**ZONING AMENDMENT &
SUBDIVISION STAFF REPORT**

Date: August 17, 2006

<u>NAME</u>	Scott Cassidy
<u>SUBDIVISION NAME</u>	Greenfield Acres Subdivision, Resubdivision of Lots 6 & 7
<u>LOCATION</u>	4521 and 4819 Colgate Drive (Northeast corner of Rangeline Service Road and Colgate Drive)
<u>CITY COUNCIL DISTRICT</u>	District 4
<u>PRESENT ZONING</u>	R-1, Single Family Residential
<u>PROPOSED ZONING</u>	I-1, Light Industry
<u>AREA OF PROPERTY</u>	1.1± Acre
<u>CONTEMPLATED USE</u>	Construction company with outside storage It should be noted, however, that any use permitted in the proposed district would be allowed at this location if the zoning is changed. Furthermore, the Planning Commission may consider zoning classifications other than that sought by the applicant for this property.
<u>REASON FOR REZONING</u>	Since the annexation of this area the commercial uses remained within the R-1, Single-Family designation. However, adjacent property to the North has been continuously used as a trucking company.

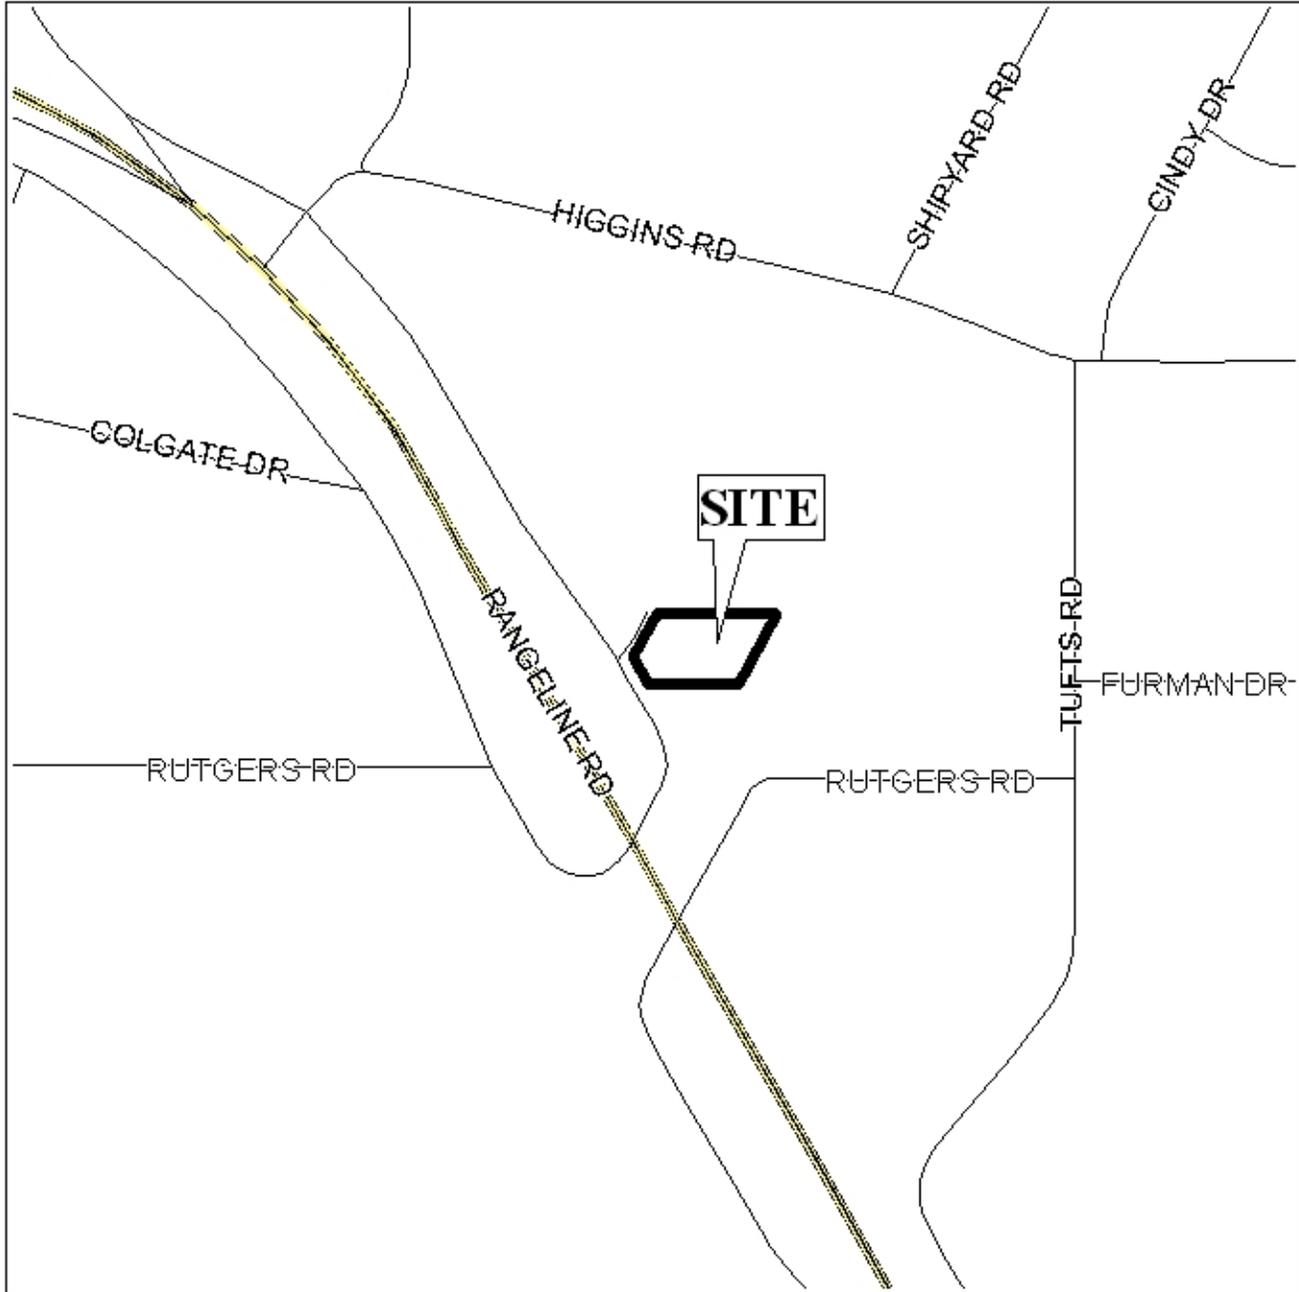
The site fronts Rangeline Road, a major street with a variable right-of-way, and Colgate Drive, with a 50-foot right-of-way. The preliminary plat indicates limited access (81-feet) to Rangeline Service Road and access to Colgate Drive; however, it does illustrate existing curb-cuts onto Colgate Drive. Since the development pattern would be unchanged from the existing subdivision, it would seem that the development of the site as commercial be similar; therefore, the conditions concerning access would be similar. Therefore, access to Rangeline Service Road should be denied; and the development should be allowed one curb-cut to Colgate Drive, exact size, location and design to be approved by the Traffic Engineering Department.

Regarding the proposed subdivision, the site would meet the minimum requirements of the Subdivision Regulations. The building setback lines are not shown and would be required on the final plat, with 25-foot setbacks from both Rangeline Road and Colgate Drive.

The site plan illustrates a 1,325 square-foot building, which requires 5 parking spaces, as illustrated on the site plan. Whereas the applicant provides the minimum required parking spaces for the building, but does not allow for warehouse or storage yard employees. Also while adequate area for maneuvering of vehicles within the yard by delivery vehicles may exist, it is required to be paved. No such facilities are reflected on the plan submitted. Finally, the site plan does not illustrate the required landscaping and tree planting requirements of the Ordinance, but does appear to provide adequate space for it. Therefore, revisions to the site plan would need to address parking, maneuvering, circulation, and landscaping and tree planting requirements. While rezoning would not be site specific, the applicant should be aware that these requirements could limit the size of the development that could be approved at this site.
